# **POSITION PAPER**

## ON THE REVIEW STUDY AND IMPACT ASSESSMENT FOR THE EXTERNAL POWER SUPPLY ECODESIGN REGULATION (2019/1782)

21 December 2023

Figure 1: Non-detachable cable on a USB-C charger

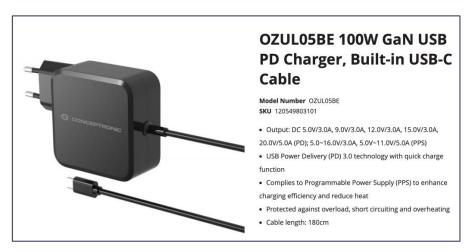
The statement in the current annexes that an AC-DC EPS "shall be a USB power supply" is insufficiently specific to ensure cables are detached from the EPS. There are EPSs on the market sold as USB power supplies that have the cable integrated to the charger, as shown in the example below.

Action: Clarify the wording to make it directly clear that EPS cables must be detachable. LACK OF CLARITY ON USB INTEROPERABILITY EXEMPTIONS The exemption on inaccessible locations needs to be clarified to avoid creating a loophole. We consider that rather than completely excluding toys, an SR should be launched to revise the toy safety standards and ensure that they are brought up to date with the new possibilities of USB interoperability for indoor use. Further, it is crucial to ensure that any exemptions addressing peak power are sufficiently robust and precise to avoid opening loopholes, e.g., directly specifying it is for EPS required to withstand audio peaks from loudspeakers. Relying on a documentation requirement to achieve this is insufficient.
